CERTIFICATE OF APPROPRIATENESS PLACARD

410 Glenwood Ave

COA-0148-2025

Material and Detail Modifications to Previously-Approved COA

CONTENT: FACADE SYSTEMS - RESIDENTIAL
STOREFRONT AT LOGGIAELEVATION AT LOGGIA 4
1/8" = 1'-0"ENLARGED ELEVATION- RESIDENTIAL LOGGIA 1
3/8" = 1'-0"ENLARGED PLAN AT LOGGIA 2
3/8" = 1'-0"SECTION AT RESIDENTIAL LOGGIA 3
3/8" = 1'-0"

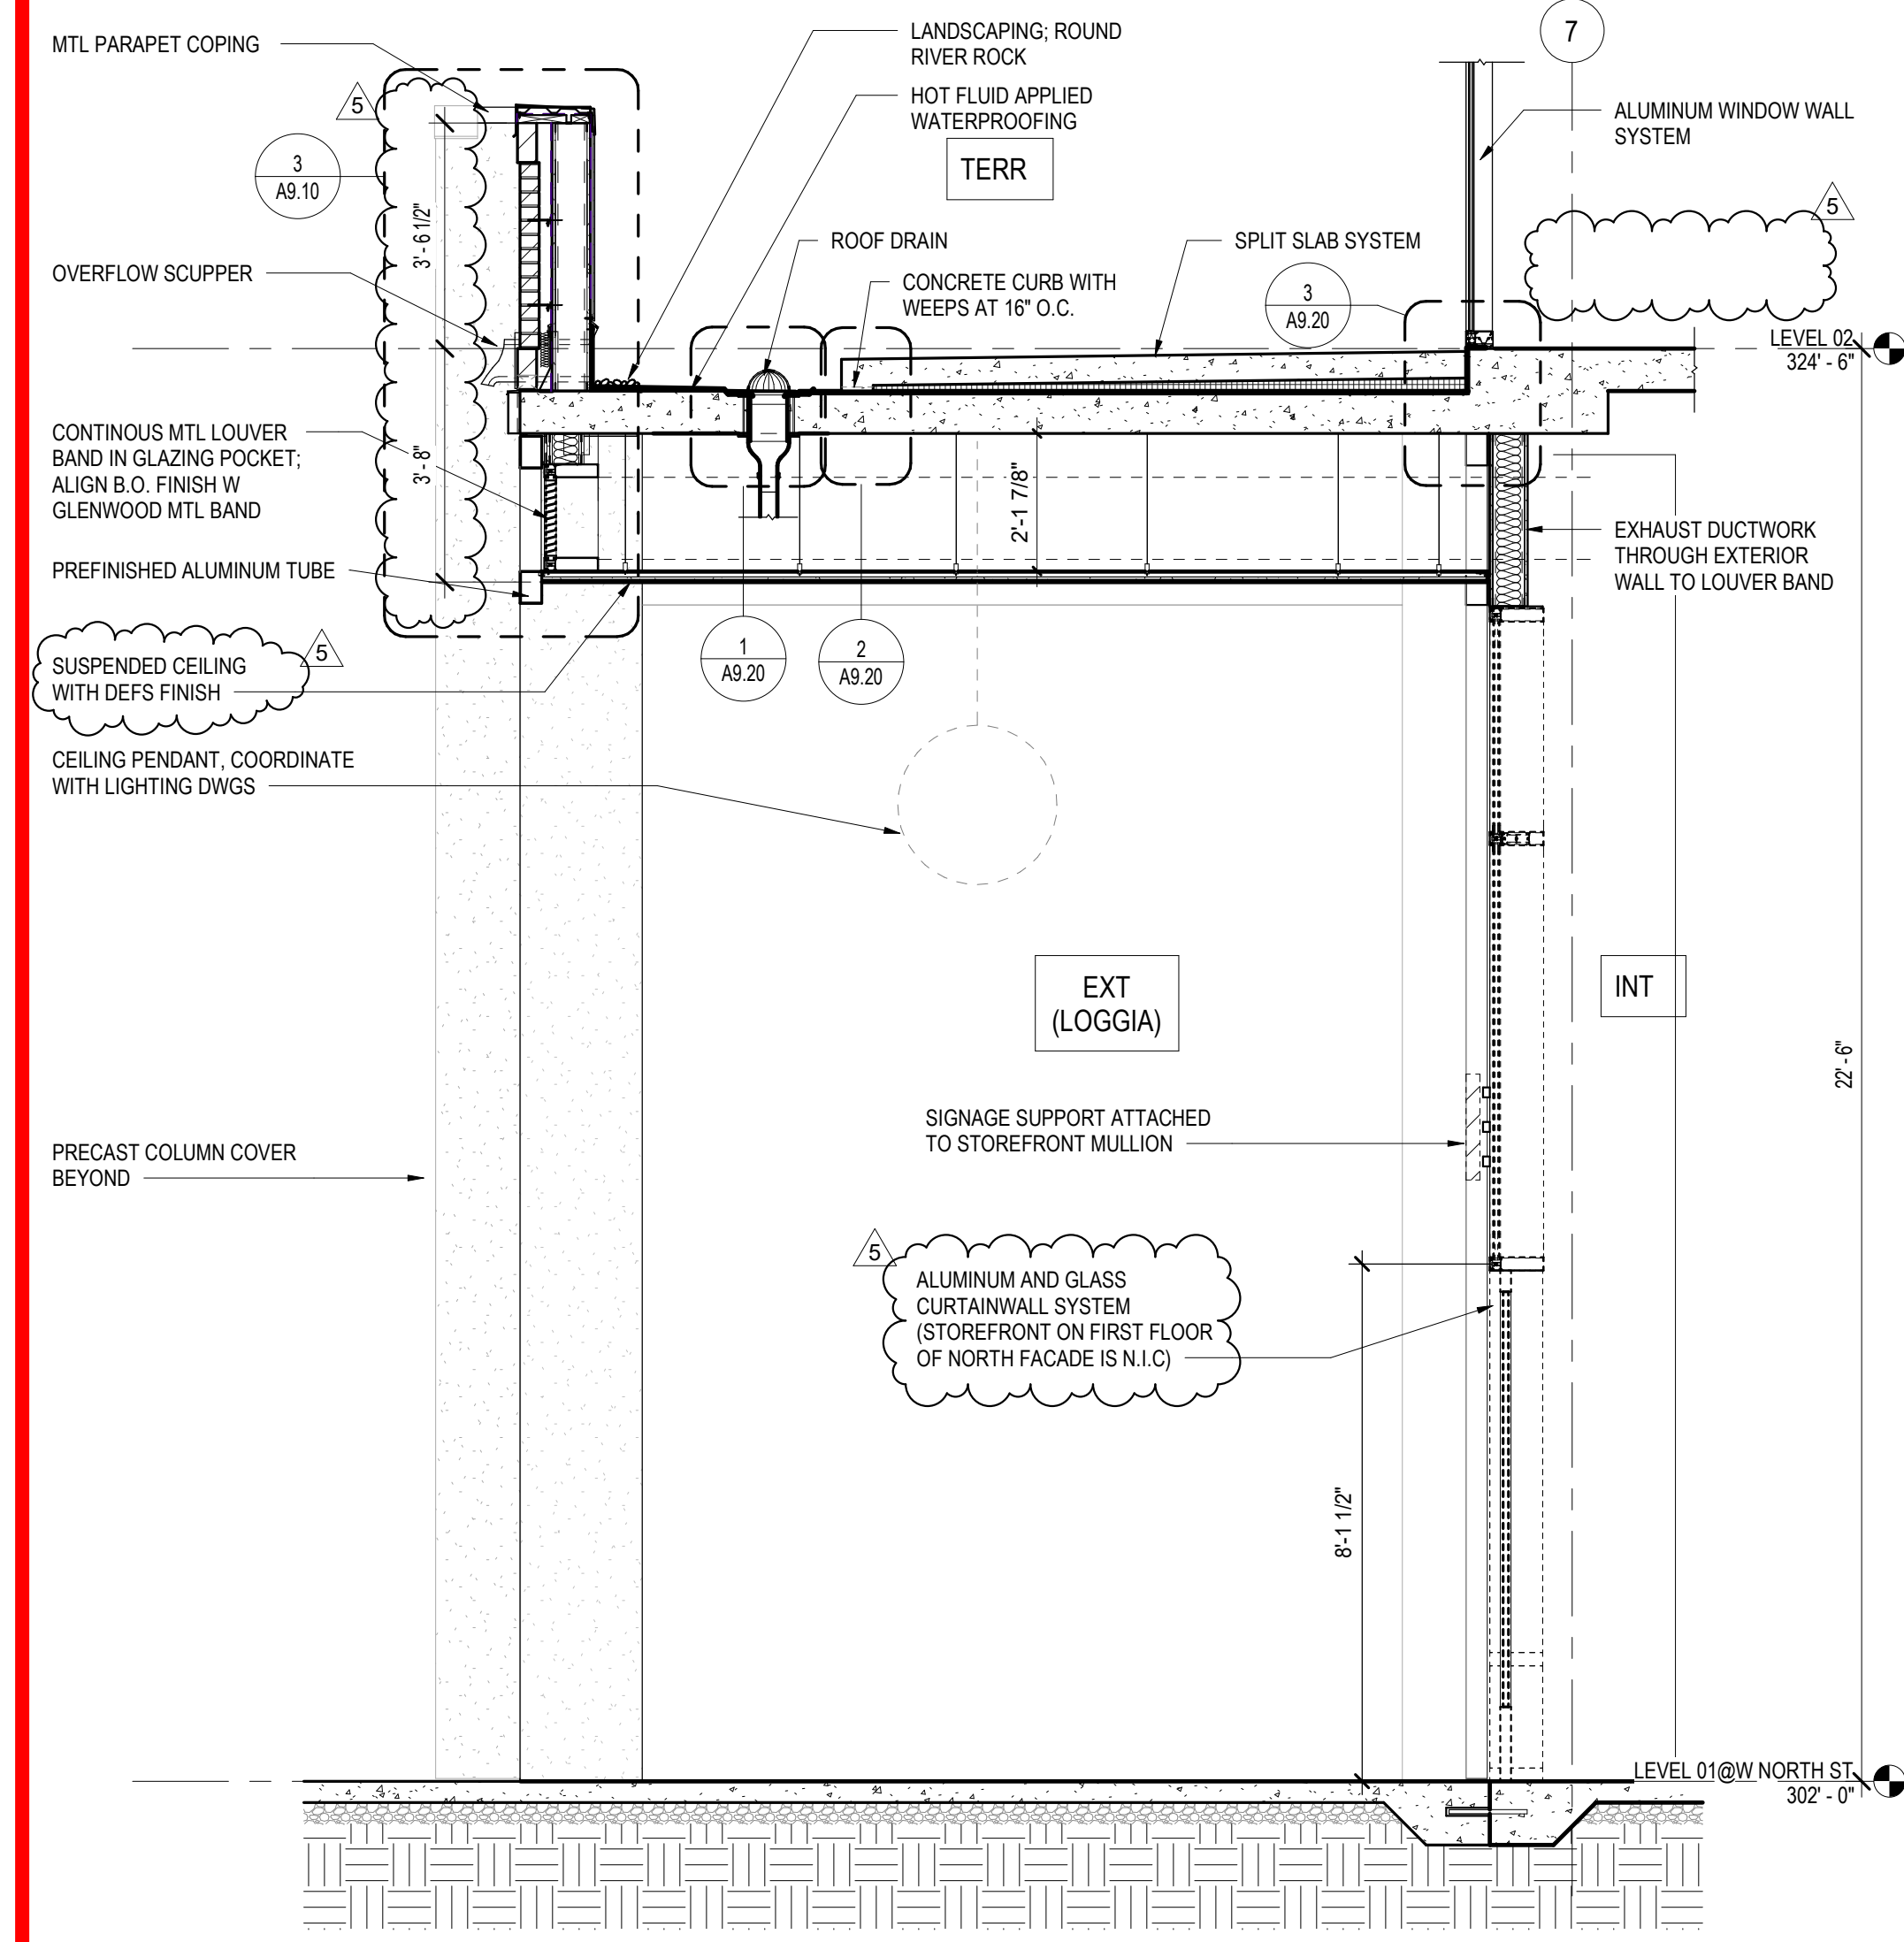
1. Minimal modifications to the loggia include:
 - The precast concrete frame and the five associated bay sizes remain consistent with the previously-approved COA. The details of the precast loggia columns remain consistent with the previously-approved COA.
 - To maximize the amount of glazing at the street level storefront, the signage band has been removed and the louver band required to meet HVAC requirements has been shifted from the building wall to the fascia. To accommodate the louvers while maintaining consistency with the massing and proportion of the previously-approved design, the parapet wall has been revised from steel railing to brick.
 - At the fascia, the previously-approved blue glazed brick has been revised to buff colored brick to match the new brick used elsewhere in the project.

1. Side-by-side rendered elevations for the previously-approved and currently proposed elevation illustrates these modifications.
2. Architectural drawing 1/A3.72 illustrates a typical loggia bay and 4/A3.72 shows the storefront at the building wall behind the loggia. Architectural drawing 3/A3.72 illustrates the section cut through the loggia.
3. A graphic material key shows material colors and selections for the building.
Material samples and colors will be delivered to the RHDC office.
